# COMMITTEE OF ADJUSTMENT

### MINOR VARIANCE REPORT

APPLICATION: CAV A/164/2022 RELATED FILE: N/A

CAV A/164/2022 - 509 Dundas St W (West District) (OP Designation: Dundas Street Urban Core Area)

**Visitor Parking Space**

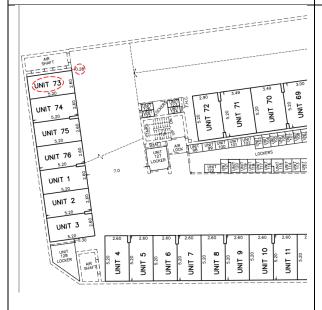
- 1. The applicant is seeking relief from Zoning By-law 2014-014, as amended, to permit the width of visitor parking space from 2.6 m to 2.5 m with a reduction of 0.02 m.
- 2. The applicant is seeking relief from Zoning By-law 2014-014, as amended, to permit the width of parking space for unit 73 from 2.90 m to 2.88 m with a reduction of 0.02 m.
- 3. The applicant is seeking relief from Zoning By-law 2014-014, as amended, to permit the parking space to have the obstruction length for unit 2 from 1.15 m to 1.86 m with a reduction of 0.02 m.

Staff have no concerns with the reduced parking space width for visitor space and Unit 73 noting a minor decrease of 0.02 m.

Staff have no concerns with the variation in obstructions that projects into the parking space widths. However, Staff do recommend that the prospective purchasers of units be made aware of said obstructions and deviations from the parking space requirements in relation to the parking of their particular vehicle.

Staff are satisfied that all three deficient parking spaces would continue to function as intended. This includes space to maneuver a vehicle to enter and exit each parking space, and the ability to open a car door to enter and exist the parked vehicle.

- 3. That the Owner apply for a note to file and update the approved parking plans in relation to the approved site plan (SP.1320.005/01), and that plan submitted in support of plan of condominium application 24CDM-21006/1320 be amended to identify the revised dimensions of the visitor parking space, unit 2 and unit 73, subject to this minor variance approval, to the satisfaction of the Director of Planning Services.
